# Curlew St Streetscape Upgrade Pre-Construction Concept Design Road Safety Audit

14 March 2023

## Pre-Construction Concept Design Road Safety Audit

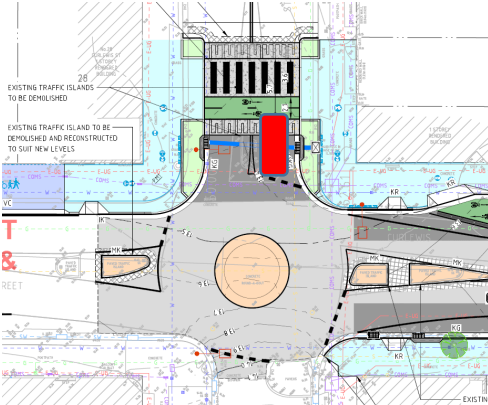
Item No.	Location	Descriptions of Findings	Design/ Photo	Likelihood	Severity	Risk Rating	Designer Response
1.	Diverge Point to Blair Street on Curlewis Street	<p>Drivers may not be aware of the diverge point on Curlewis Street as a result of the following issues:</p> <ul style="list-style-type: none"> <li>The sign plan does not show the existing direction sign for Bondi Beach. However it is likely to be relocated to make way for the proposed shared path.</li> <li>Pavement arrows give late notice of the split in traffic, road users not familiar with the area may make late lane change to avoid taking the wrong turn.</li> <li>The gore area is not well delineated with insufficient line marking and signage to emphasise its presence.</li> </ul> <p>Late lane change may cause turbulence in the traffic stream, which may increase the risk in side-swipe and rear-end collisions.</p> <p>Furthermore, the proposed shared path and crossing point are located directly behind the gore area which is not well delineated. There is a risk of errant vehicles colliding into the shared path which may result in conflicts with pedestrians and cyclists.</p>	 	Occasional	Moderate	Medium	<p>The risk is noted, and directional signage will be relocated and shown on final drawings. It is noted that the diverge is an existing condition and provision of the off-road cycleway improves the safety.</p>

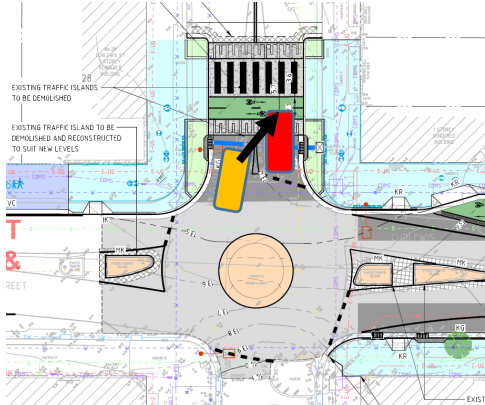
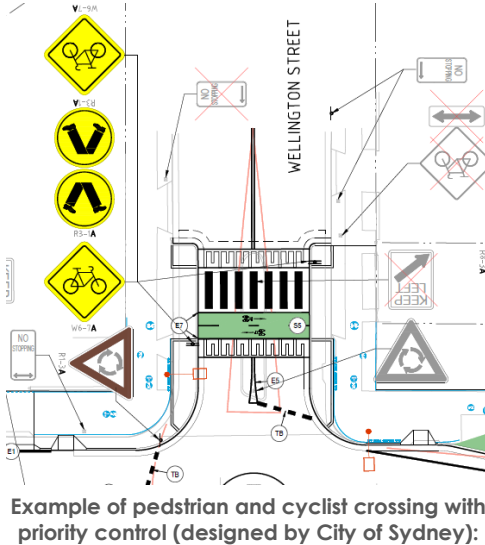
Item No.	Location	Descriptions of Findings	Design/ Photo	Likelihood	Severity	Risk Rating	Designer Response
3.	Old South Road and Curlewis Street intersection	<p>The shared through and right turn lane is 2.7m wide on Curlewis Street westbound, and may not be sufficient to accommodate the design vehicle along the curve towards the intersection, noting that the existing central median will be removed.</p> <p>Vehicles not staying within the lane may result in a side-swipe incident with vehicles in the adjacent lane.</p>		Improbable	Moderate	Low	<p>The lane widths are increased vs existing due to removal of on-road cycleway. However, it's noted the removed median does increase the risk. The risk is mitigated by the fact that only heavy vehicles sweep close to the extents of the BB line.</p>

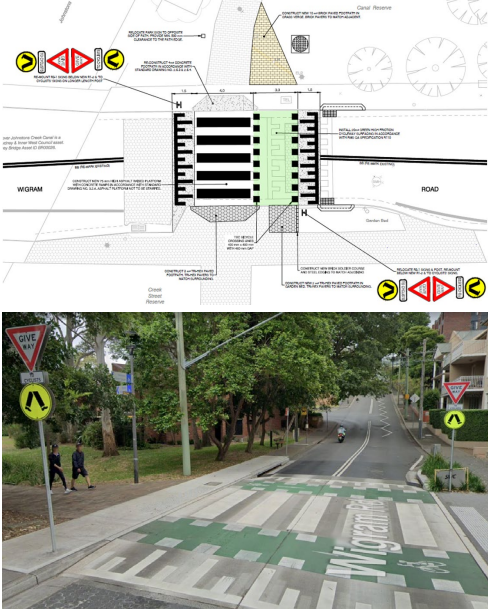
Item No.	Location	Descriptions of Findings	Design/ Photo	Likelihood	Severity	Risk Rating	Designer Response
5.	Curlewis Street and Blair Street intersection	<p>The design does not provide a crossing facility nor a clearly defined priority for shared path users at the crossing point in Blair Street.</p> <p>For cyclists travelling straight across Blair Street, this location is immediately following a diverge point.</p> <p>This may increase the risk of collisions with shared path users.</p>		Improbable	Moderate	Low	It is preferred to avoid a priority crossing for pedestrians/cyclists at this location due to proximity to the Old South Head Road intersection and potential impacts to that intersection

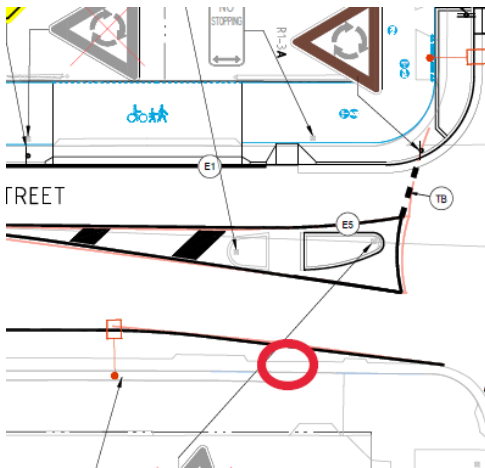
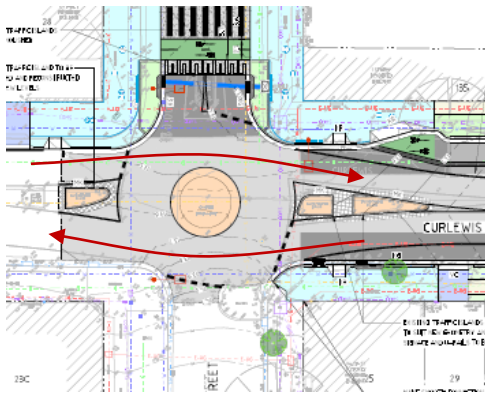
Item No.	Location	Descriptions of Findings	Design/ Photo	Likelihood	Severity	Risk Rating	Designer Response
8.	Wellington Street – Pedestrian Crossing	There does not appear to be 6m between the give way line marking on the Wellington Street north approach. Consequently, vehicles may encroach the cycleway crossing which may lead to conflict with cyclists. This safety concern is exacerbated when a large vehicle waits at the give way line.	 	Improbable	Moderate	Low	Currently around 5m clearance is achieved, suitable to accommodate most light vehicles. Unfortunately due to existing driveways it is not possible to set the crossing back any further. It is noted that any heavy vehicle would encroach on the crossing even with a 6m setback.

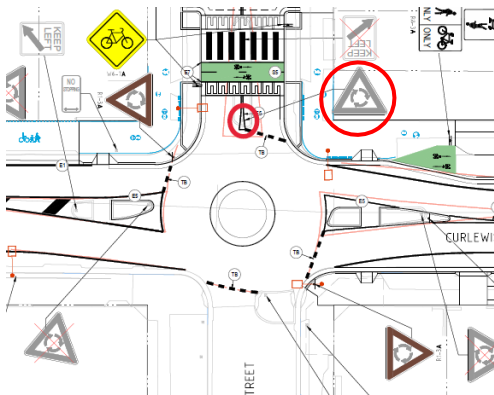
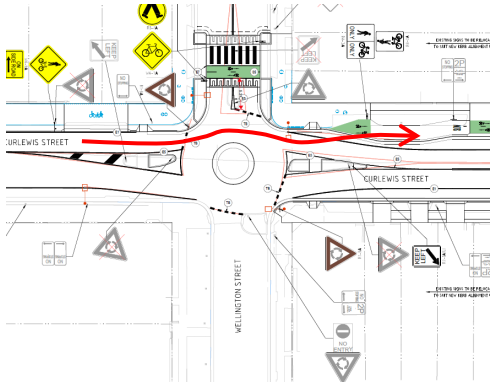
Item No.	Location	Descriptions of Findings	Design/ Photo	Likelihood	Severity	Risk Rating	Designer Response
9.	Wellington Street – Pedestrian Crossing	<p>Motorists waiting on the Wellington Street north approach to the roundabout may restrict visibility to motorists traveling northbound on Wellington Street.</p> <p>This would increase the likelihood of conflicts with cycleway users at this location.</p> <p>Lastly, if the pedestrian and cycle crossing is busy, the roundabout operation may become gridlocked which may lead to driver frustration and illogical driver behaviour.</p>		Improbable	Moderate	Low	<p>This configuration is true of any near-intersection raised threshold and the combination of the raised threshold and warning signage is relied upon to reduce vehicle speeds.</p> <p>Traffic analysis of the crossing has been undertaken which suggests the crossing will not have an adverse impact on roundabout performance.</p>

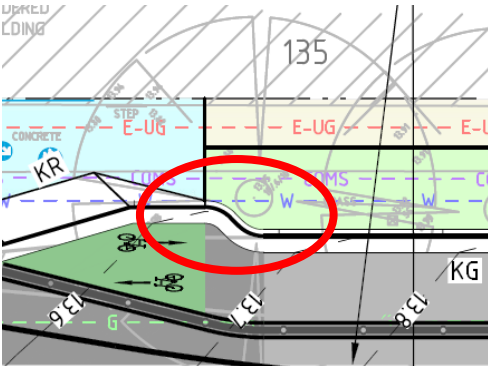
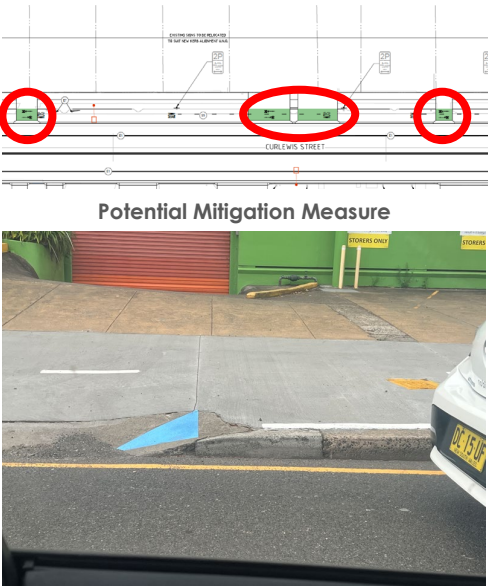
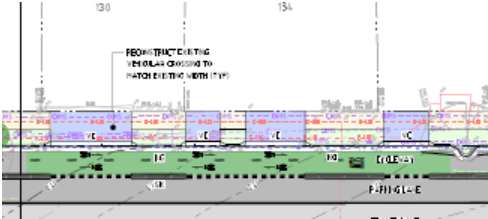
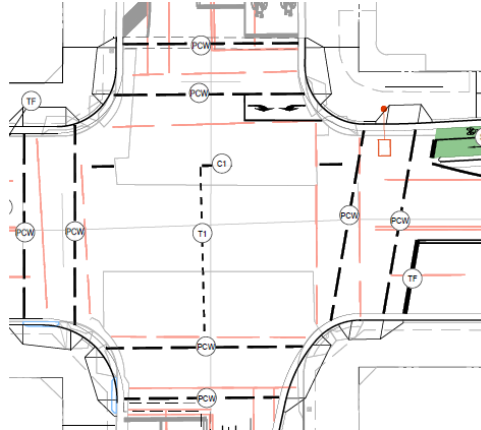
Item No.	Location	Descriptions of Findings	Design/ Photo	Likelihood	Severity	Risk Rating	Designer Response
11.	Wellington Street, Curlewis Street roundabout	<p>No kerb ramp has been provided on the south side of the west leg of the Wellington Street and Curlewis Street roundabout.</p> <p>Absence of the kerb ramp would not provide a smooth transition between the roadway and footpath for pedestrians with prams and in wheelchairs. They may walk in the roadway and cause conflicts with passing vehicles.</p>		Improbable	Moderate	Low	<p>This is an existing condition with no works proposed to the southern kerb line at this location. Consideration is being given to the feasibility of providing a kerb ramp here, which may be included in the final design</p>

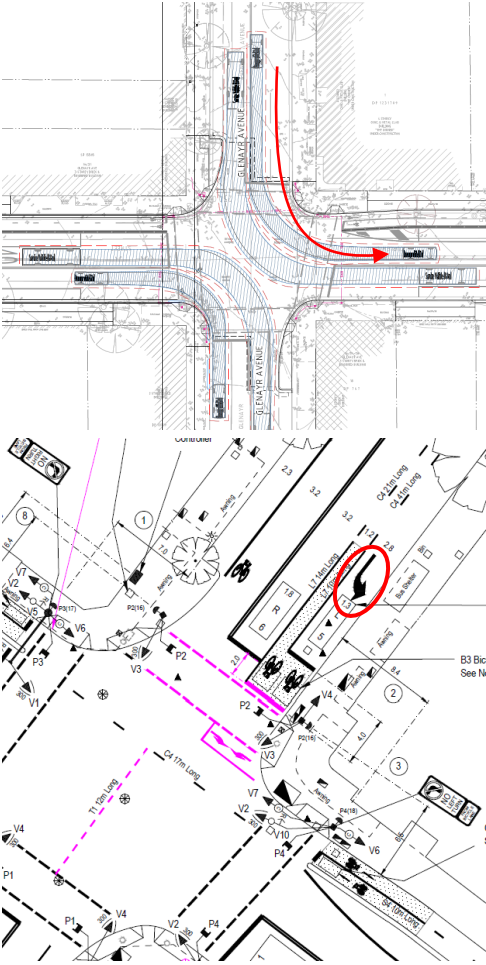
Item No.	Location	Descriptions of Findings	Design/ Photo	Likelihood	Severity	Risk Rating	Designer Response
13.	Wellington Street, Curlewis Street roundabout	<p>A 'Roundabout Give Way' sign is located within a small painted median island on the north leg of the roundabout.</p> <p>The signpost could be knocked down by turning vehicles in the absence of a raised median island. This could possibly cause injury to passing cyclists on the crossing or damage other vehicles.</p> <p>This could also result in vehicles not noticing the signage and entering the roundabout not expecting to give-way to other vehicles to their right, resulting in incidents.</p>		Improbable	Moderate	Low	The sign will be relocated to the LHS verge in the final design.
14	Wellington Street, Curlewis Street roundabout	<p>Confident cyclists cycling eastbound on Curlewis Street may avoid the shared path facility west of Wellington Street, however they may want to connect with the cycleway when it transitions to a bi-directional cycleway.</p>		-	-	Note only.	Consideration is being given to providing this facility in the final design

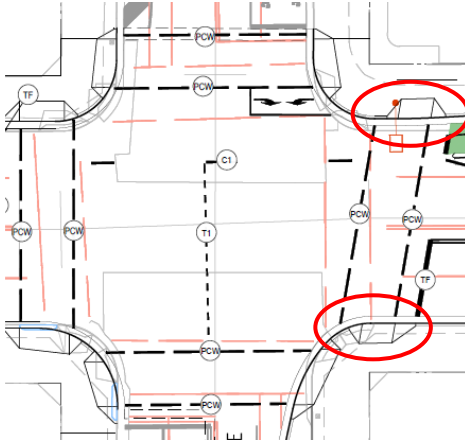
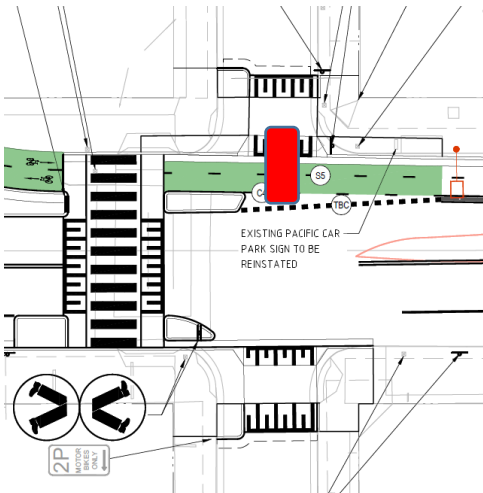
Item No.	Location	Descriptions of Findings	Design/ Photo	Likelihood	Severity	Risk Rating	Designer Response
17.	East of Wellington Street	There is a sharp change in kerb alignment for eastbound cyclists east of Wellington Street. Cyclists may not be aware of the change in alignment particularly during night-time conditions. This issue is exacerbated when following another cyclist when forward visibility is limited.		Improbable	Moderate	Low	This hazard is reduced by the adopted raised cycleway option, which removes the kerb at this location.

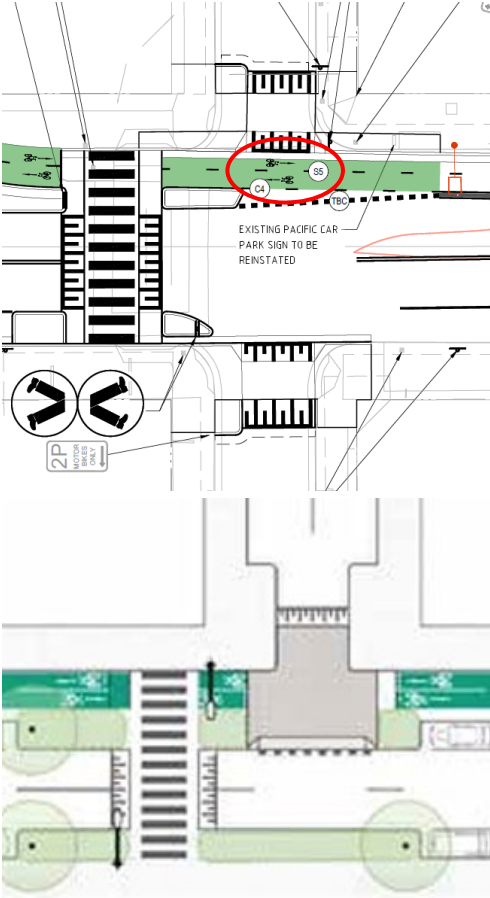
Item No.	Location	Descriptions of Findings	Design/ Photo	Likelihood	Severity	Risk Rating	Designer Response
20.	Glenayr Avenue and Curlewis Street intersection	<p>The hook turn bay is 4.3 to 5.2m long to accommodate eastbound cyclists waiting to turn right, and westbound cyclists waiting to turn left towards Glenayr Avenue southbound.</p> <p>Considering Austroads require 3m for the hook turn bay (one direction), the proposed bay is too short to accommodate two bicycles in opposite directions. This may result in conflicts between cyclists, or cyclists storing outside the hook turn bay.</p> <p>Furthermore, the hook turn bay has no bicycle line marking (i.e. green paint and bike symbol) and therefore may not be used correctly. Cyclists may ignore this and will use a conventional right-turn which has a greater risk of collision with vehicles.</p> <p>Of note, hook turns can be used as an alternative to a conventional right-turn from the centre of the road under the <i>Australian Road Rules (National Transport Commission 2012)</i>, however, there is no mention of left turn hook turns within the Austroads Guide.</p> <p>Lastly, consideration should be given to providing a hook turn for the Glenayr Avenue to Curlewis Street right turn movement.</p>		Occasional	Minor	Low	<p>This item will be further explored with TfNSW as the project seeks Approval In Principle for the TCS design.</p> <p>The left turn from Curlewis Street to Glenayr Avenue (southbound) is consistent with the intent of providing a safe turning opportunity and the absence of any sheltered facility may result in irrational cyclist behaviour (e.g. moving into the vehicular traffic stream).</p>

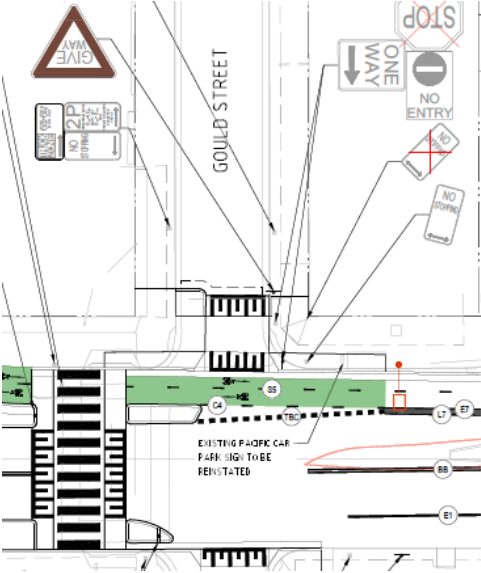
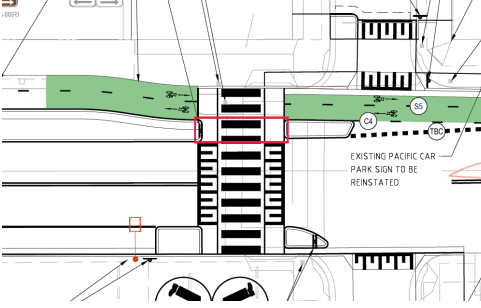
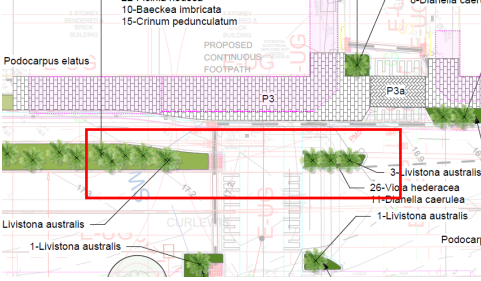
Item No.	Location	Descriptions of Findings	Design/ Photo	Likelihood	Severity	Risk Rating	Designer Response
21.	Glenayr Avenue and Curlewis Street intersection	The swept path assessment shows the left turn movement being made from the second lane (median lane) on Glenayr Avenue onto Curlewis Street rather than straddling both lanes. Consequently, motorists turning left from the kerbside lane may conflict with motorists turning left from the median lane.		Improbable	Moderate	Low	Swept paths will be confirmed to work while straddling the lanes.

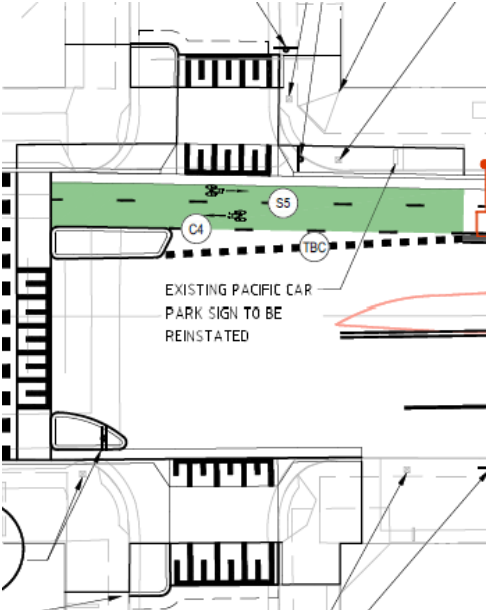
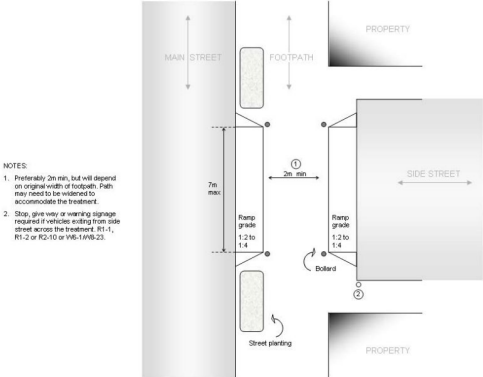
Item No.	Location	Descriptions of Findings	Design/ Photo	Likelihood	Severity	Risk Rating	Designer Response
22.	Curlewis Street, east leg at the Glenayr Avenue intersection	<p>The proposed kerb ramps are 2.3m wide in Curlewis Street and do not extend the full width of the marked foot crossings which are about 3.6m wide on Curlewis Street.</p> <p>RMS Guide to Traffic Signals Appendix D suggests kerb ramps should ideally be the full width of the crossing.</p>		-	-	Note only	Non-conformance to Appendix D to be accepted by TfNSW through Approval in Principle of the TCS design.

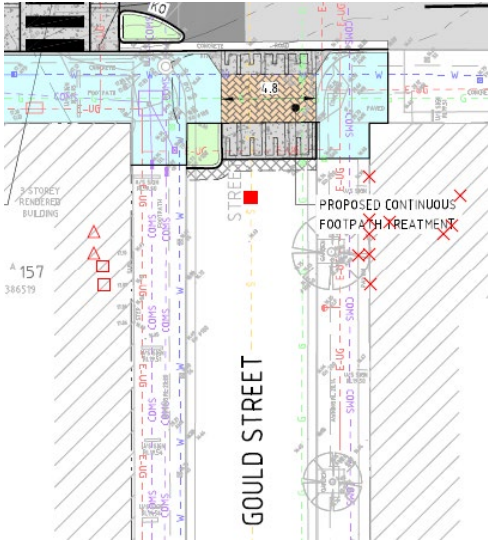
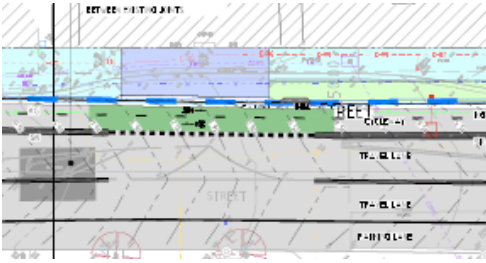
Item No.	Location	Descriptions of Findings	Design/ Photo	Likelihood	Severity	Risk Rating	Designer Response
24.	Gould Street – north approach	<p>The cycleway is not included in the raised continuous footpath treatment.</p> <p>An example design stipulated in TfNSW cycleway Toolbox involves an extension of the raised platform past the intersection.</p>	 <p>EXISTING PACIFIC CAR PARK SIGN TO BE REINSTATED</p>	Improbable	Moderate	Low	<p>A raised threshold in accordance with the Toolbox is under consideration for adoption in the final design. This would assist with the issue raised in Item 23.</p>

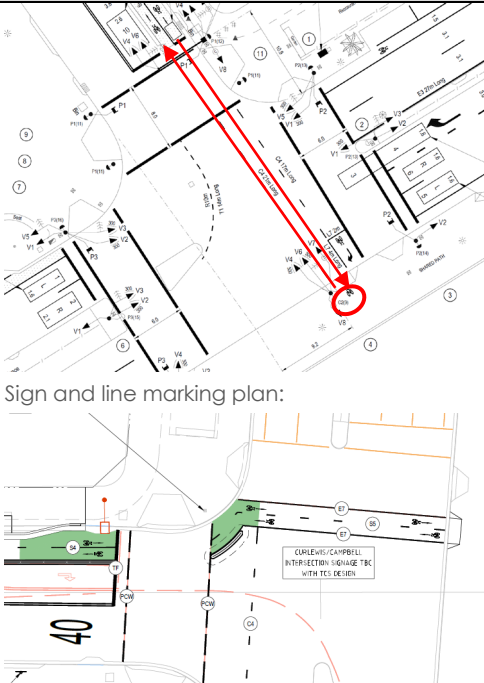
Item No.	Location	Descriptions of Findings	Design/ Photo	Likelihood	Severity	Risk Rating	Designer Response
30.	Pacific Car Park	<p>During busy periods, vehicles queueing for the boom gate when entering the car park may queue across the cycleway. This would increase the chance of a conflict between cyclists and queued vehicles.</p> <p>Cyclists may also use the roadway or footpath to avoid vehicles queued across the cycle lane which increases the chances of incidents with vehicles or pedestrians.</p>	 	Improbable	Moderate	Low	Noted, however this cannot be avoided. It is hoped that vehicle wishing to enter the carpark would queue on the road, without stopping on the cycleway. This may be monitored after construction and additional signage installed if compliance is poor.

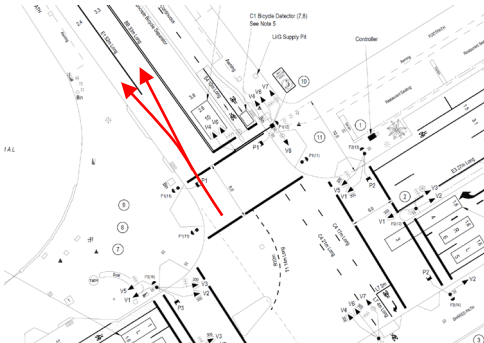
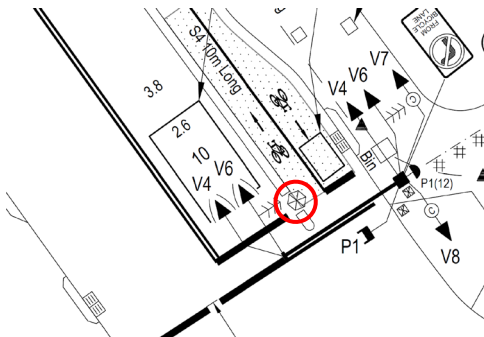
Item No.	Location	Descriptions of Findings	Design/ Photo	Likelihood	Severity	Risk Rating	Designer Response
32.	General comment	Similarly, delivery vehicles were observed parked across the driveway. In the future, these service vehicles would be parked across the cycleway. In the future, these cars may park across the cycleway, however for the purposes of this audit it is assumed motorists would not park in this location in the future.		-	-	Note only	Council will enforce legal parking as required.

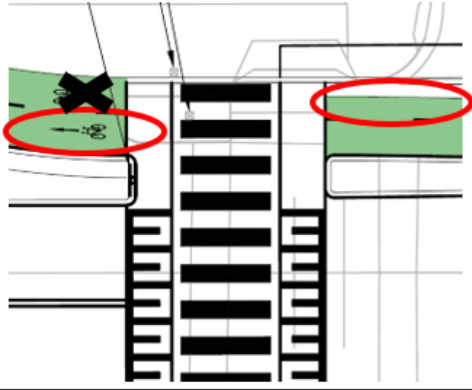
Item No.	Location	Descriptions of Findings	Design/ Photo	Likelihood	Severity	Risk Rating	Designer Response
34.	General comment	The existing trees to be retained adjacent to the cycleway have large tree roots that may disturb the cycleway pavement. Overgrowing roots may lift the pavement overtime.		-	-	Note only	Suitable pavements over the tree roots to minimise risk are currently being further explored
